**CITY OF PORTLAND, MAINE  
Portland Community Health Center Renovations  
Bid #2713**

Receipt of **Addendum No. 2** to the City of Portland's Bid #2713, **Portland Community Health Center Renovations**: is hereby acknowledged.

**CITY OF PORTLAND, MAINE**  
**Portland Community Health Center Renovations**  
**Bid #2713**

**Meeting Minutes****Mandatory Pre-Bid Meeting**

SKE-101A

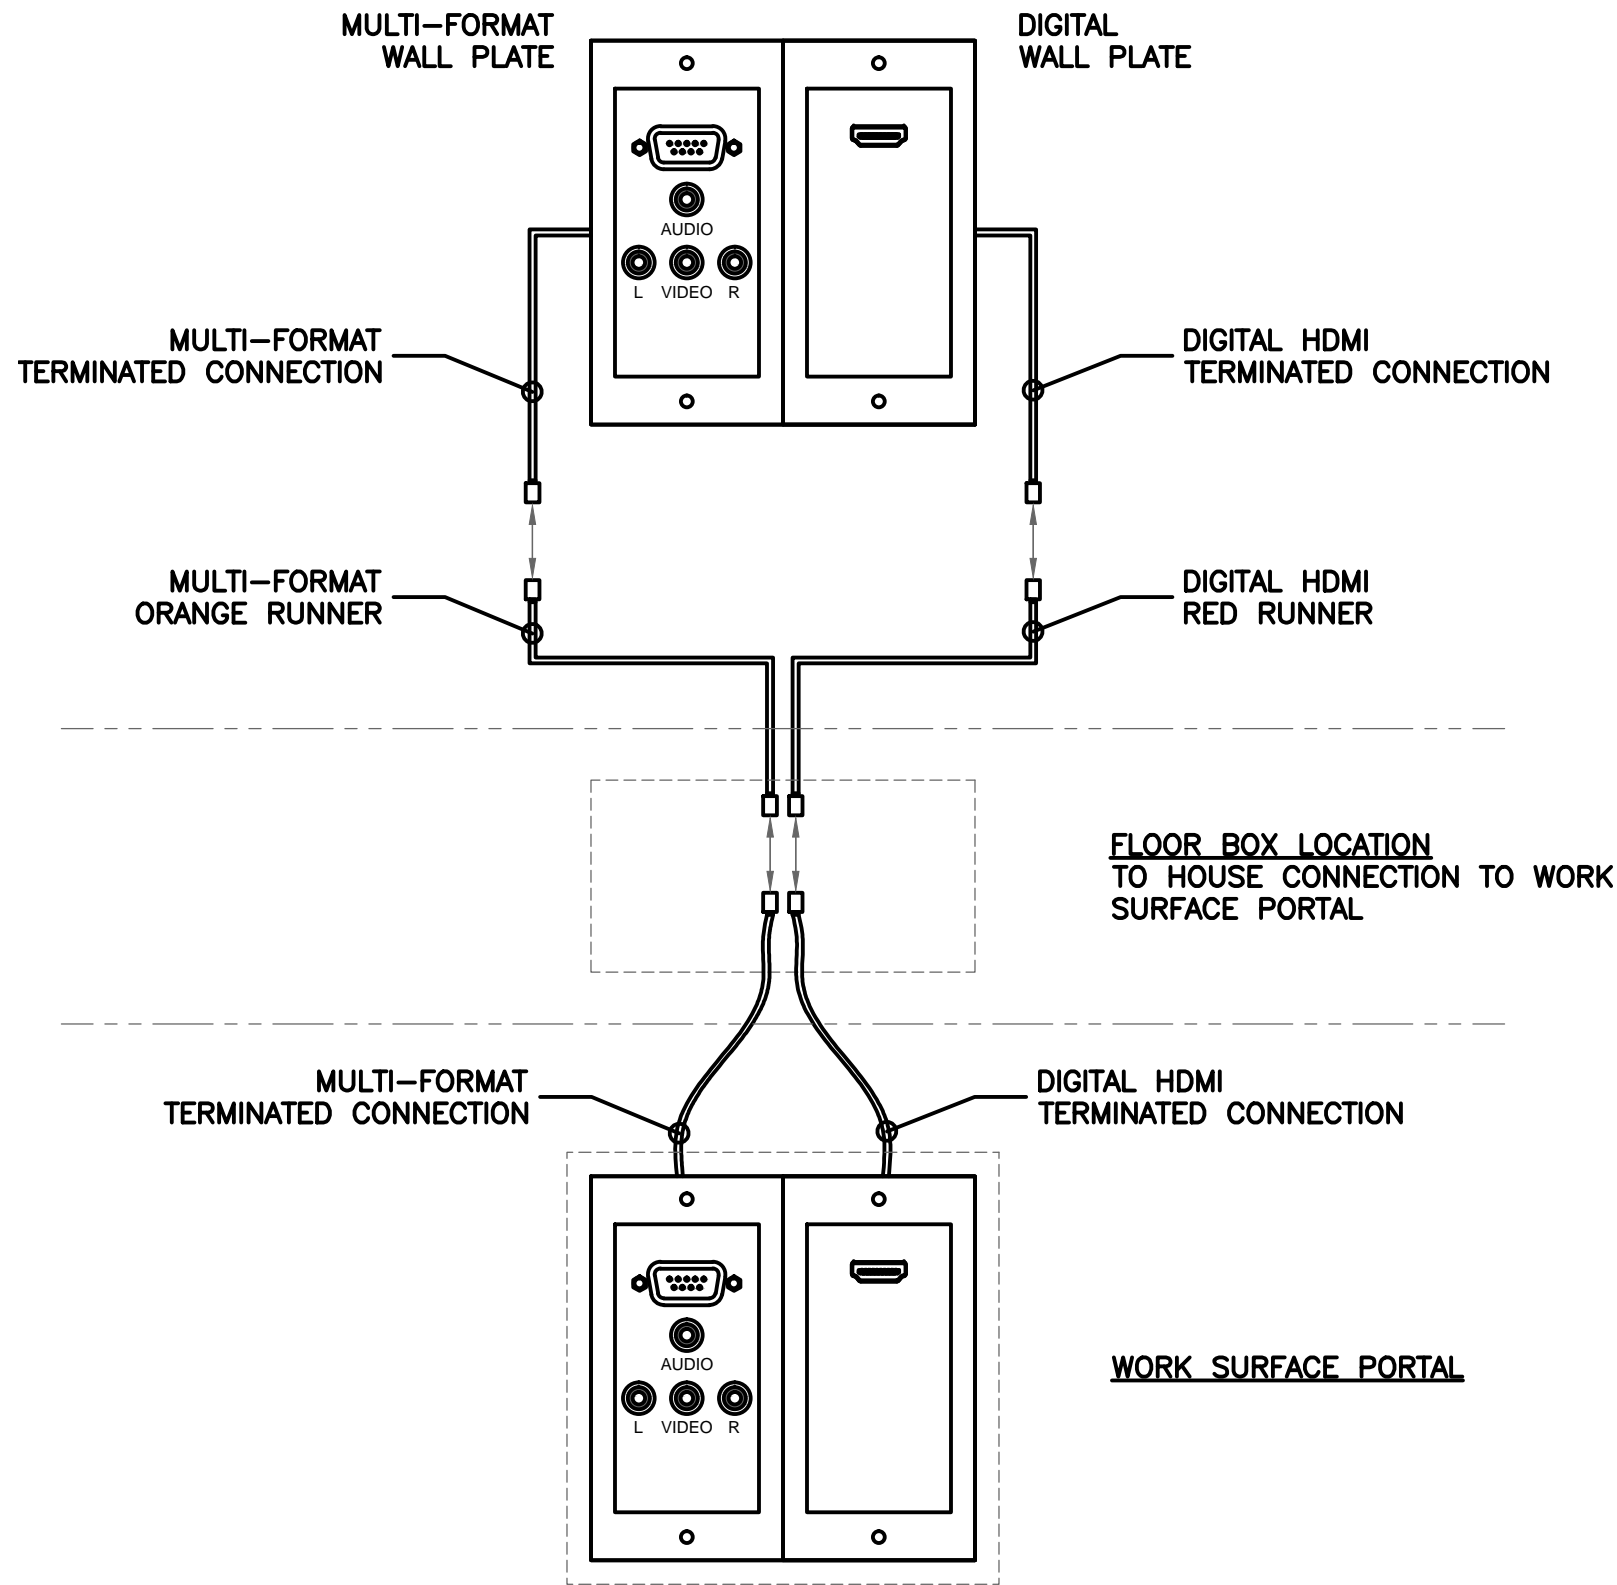
3. *The electrical spec calls out Rapid Run AV cable at the conference room. What specific type of cable is required and what are the required termination types?*

Please reference the attached SKE 101A

**E 201**

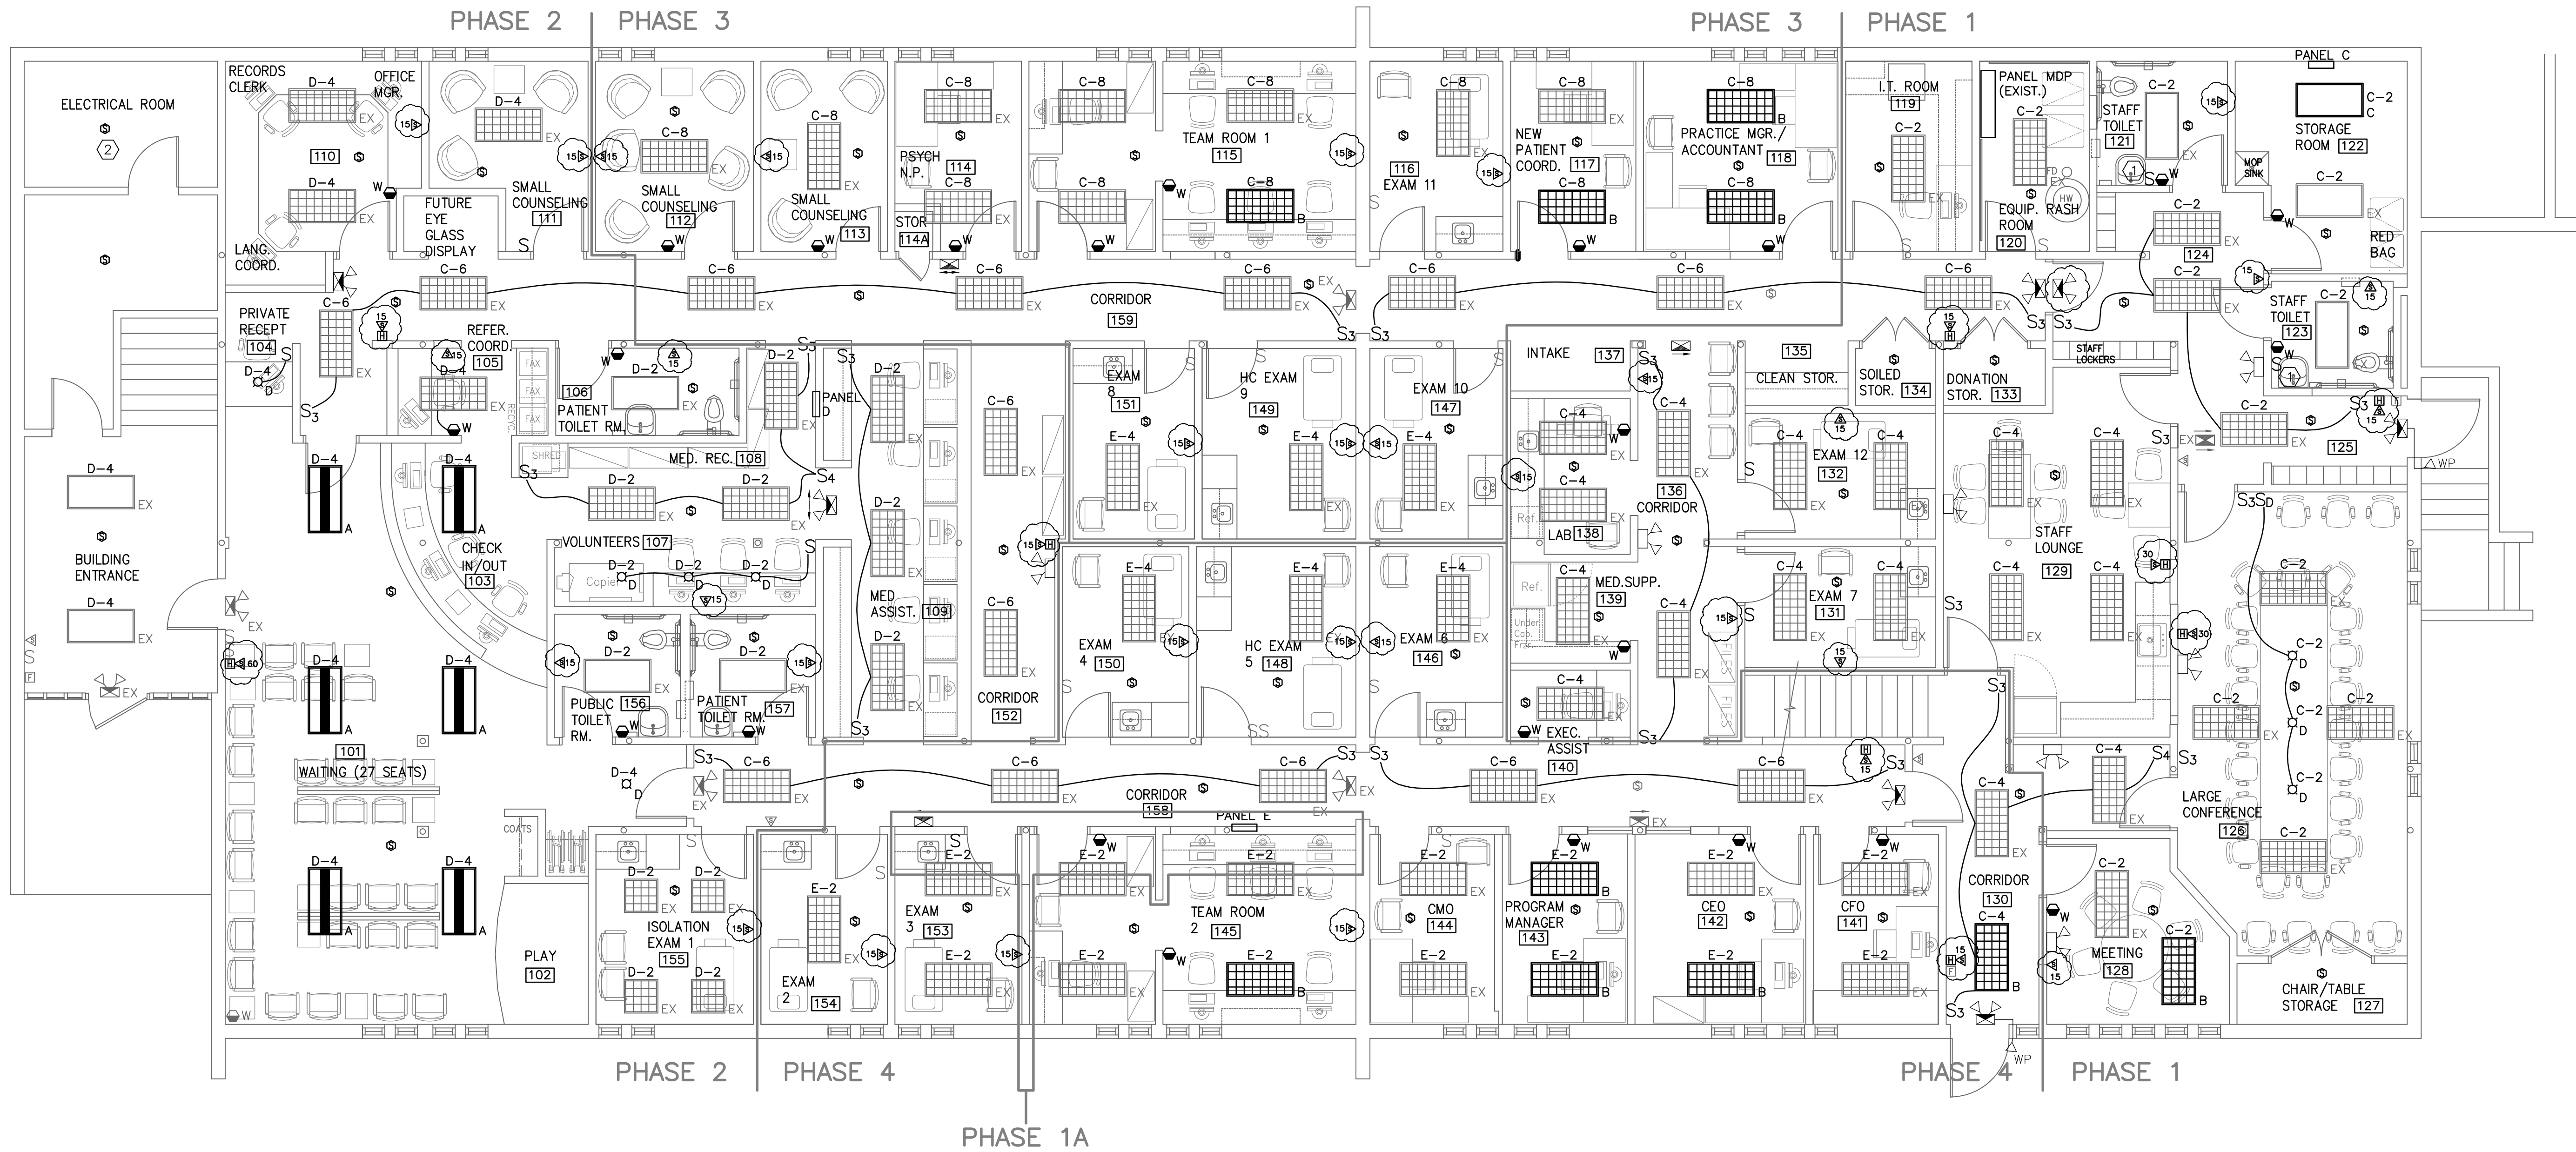
11. *Will there be any strobes in the exam rooms?*

12. *Some of the public bathrooms do not seem to have a strobe. Do they need a strobe?*

Strobe units for the exam rooms should have been shown on the original drawing E201. Attached is a revised drawing showing additional strobes and other clarifications identified by the State Fire Marshal in his review of the plans.

Strobe units for the bathrooms should have been shown on the original drawing E201. Attached is a revised drawing showing additional strobes and other clarifications identified by the State Fire Marshal in his review of the plans

- FURNISH TIME DELAY SWITCH FOR BATHROOM EXHAUST FANS. CONNECT EXHAUST FAN TO BATHROOM LIGHTING CIRCUIT. COORDINATE SWITCH WITH EQUIPMENT FURNISHED.
  - VERIFY EXISTING SMOKE DETECTOR IN FACP ROOM. FURNISH AND INSTALL NEW SMOKE DETECTOR IF THEIR IS NO EXISTING DETECTOR IN ROOM.
- REVISIONS PER FIRE MARSHALL REVIEW COMMENTS. 10.15.12
